TRUCK, DUMP, MEDIUM, WINCH, MC2 – UNIMOG

ENGINEER'S TOOL CAGE

MODIFICATION INSTRUCTION

Figure 1 Modification Detail for Left Hand Hinge Pin Shaft

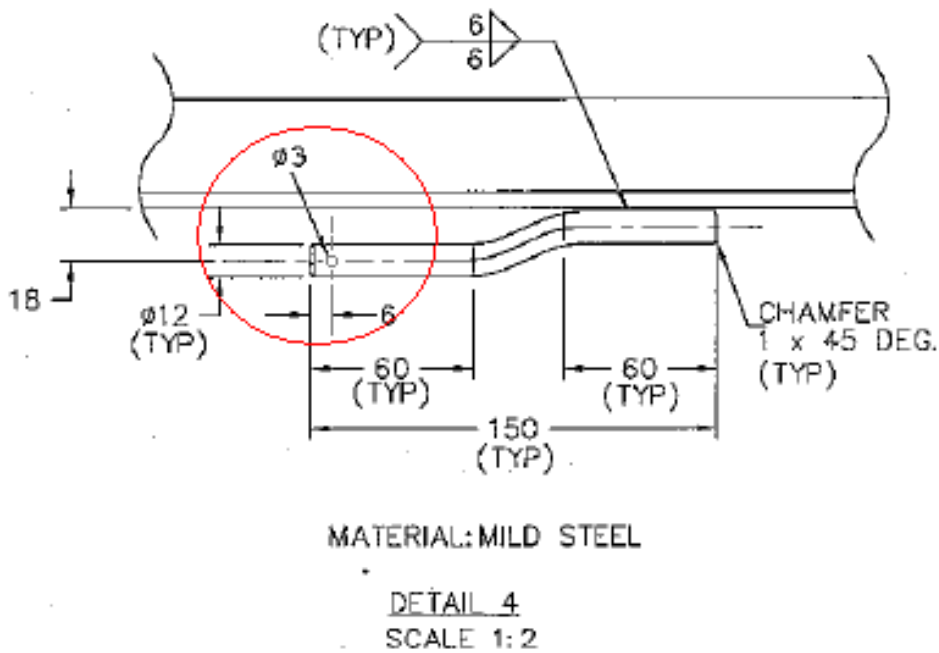
11. Drill a 3 mm hole through the shaft of the left side hinge pivot pin 6 mm from the end as detailed in Figure 1.

Modifications to detail 4 from drawing MEA 1755 - 2 are circled in red.

Figure 2 Modification Detail For Left Hinge Sleeve

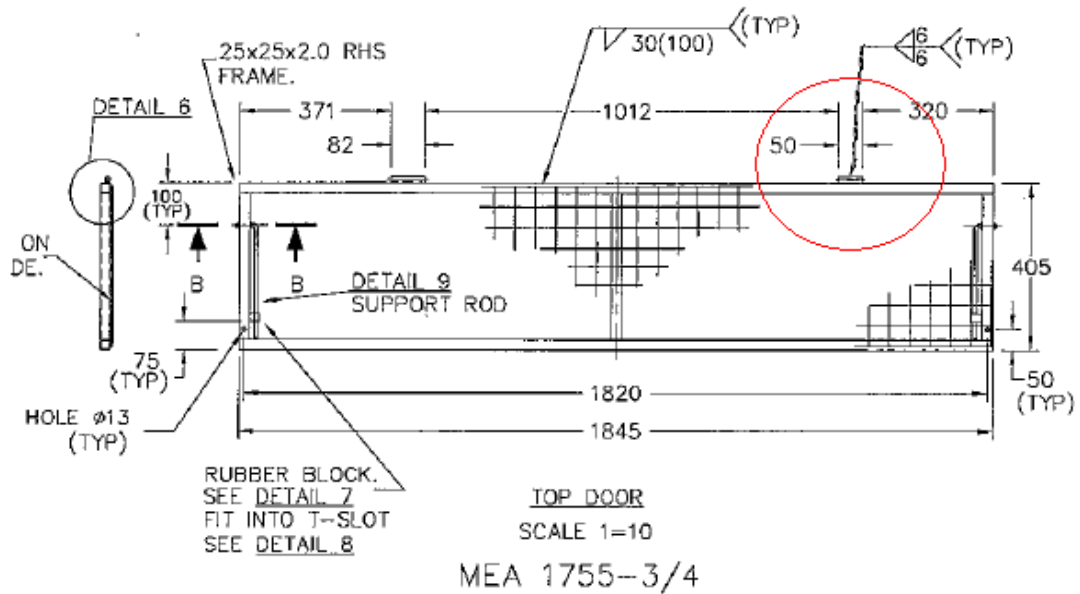
12. Shorten the left hand hinge sleeve end as detailed in Figure 2. This enables the hinge pin shaft to protrude sufficiently to fit a split pin through the previously drilled hole detailed in Figure 1.

Modifications to drawing MEA 1755 - 3/4 are circled in red.

13. Refit the door to the cage and fit a split pin (Table 1, Item 1) to the left hinge pin shaft to prevent the door from sliding off the hinge pin shaft.
